GROUP BOD	MODEL 2017MY Forte (YDm)
	NUMBER 181	DATE January 2018
TECHNICAL SERVICE BULLETIN		
SUBJECT: SERVICE ACTION: OUTSIDE REAR COMBINATION LAMP WATER INTRUSION (SA327)

This bulletin provides the procedure to replace the outside rear combination lamp pads on some 2017MY Forte (YDm) vehicles, produced from May 23, 2016 to August 15, 2017, which may exhibit evidence of water intrusion in the outside rear combination lamps. Follow the procedure outlined in this bulletin to replace both left and right outside rear combination lamp pads. Before conducting the procedure, verify that the vehicle is included in the list of affected VINS.

Right rear combination lamp shown in images below

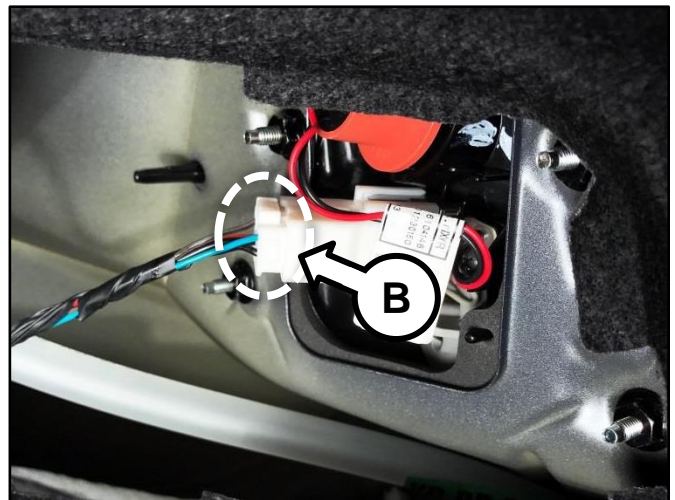
1. Open the trunk and carefully remove cover (A).

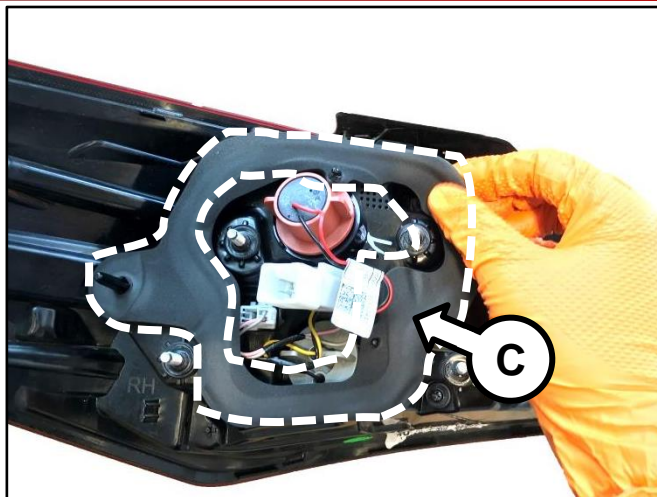
2. Unplug the connector (B) by pushing down on the lock and pulling the connector outwards.

3. Remove the four (4) retaining nuts.

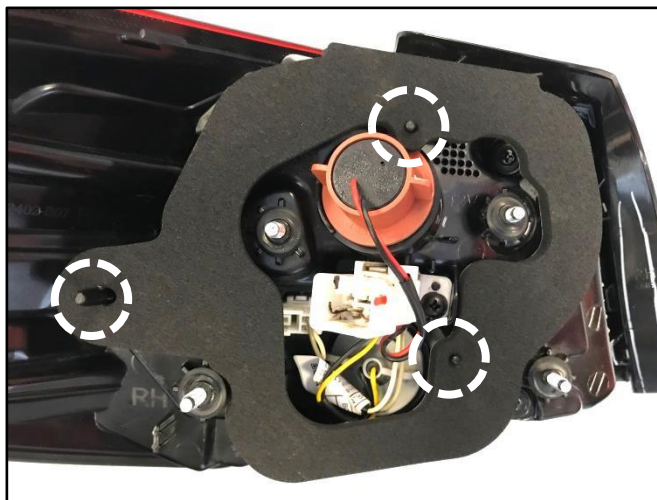
4. With the combination lamp uninstalled from the vehicle, remove and discard the pad (C).

5. Clean off any adhesive residue on the combination lamp.

If there is any moisture remaining in the combination lamp after removal, dry the interior by gently blowing non-lubricated, regulated shop air through the bulb socket (20 PSI max). Advise the customer that any remaining moisture will dry out over time.

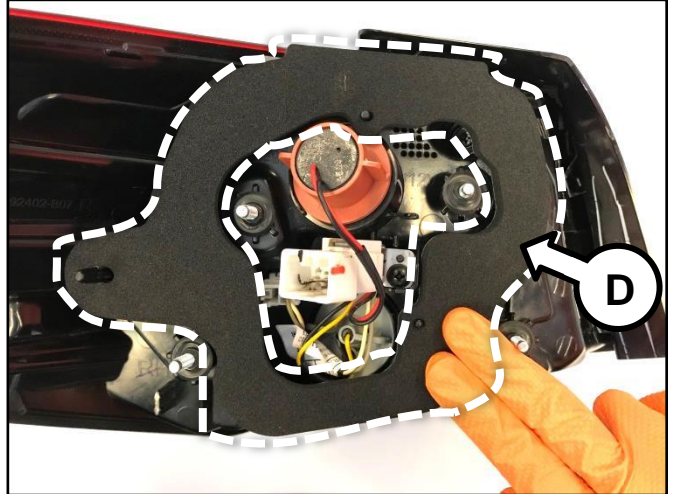
6. Remove the adhesive protector from the new pad and carefully align the new pad onto the three (3) combination lamp guide pins.

7. Firmly press on the new pad (D) onto the combination lamp and ensure the new pad is completely adhered to the combination lamp.

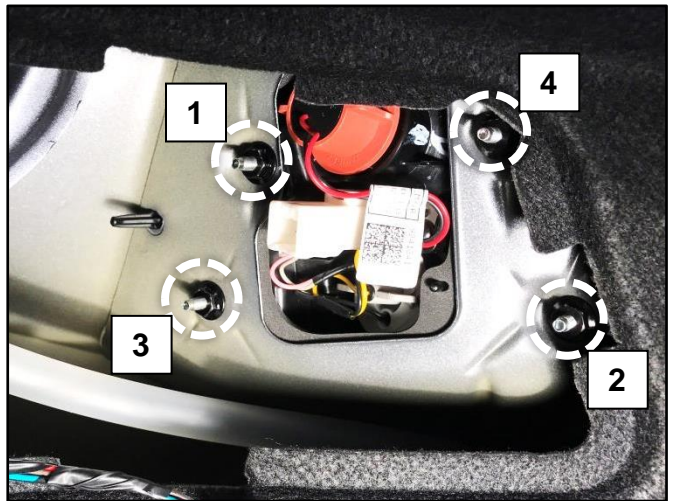
8. Reinstall the combination lamp and torque the retaining nuts in the sequence shown.

Tightening torque for nuts:
41.6 in.lb (4.71 N.m, 47.8 kgf.cm)
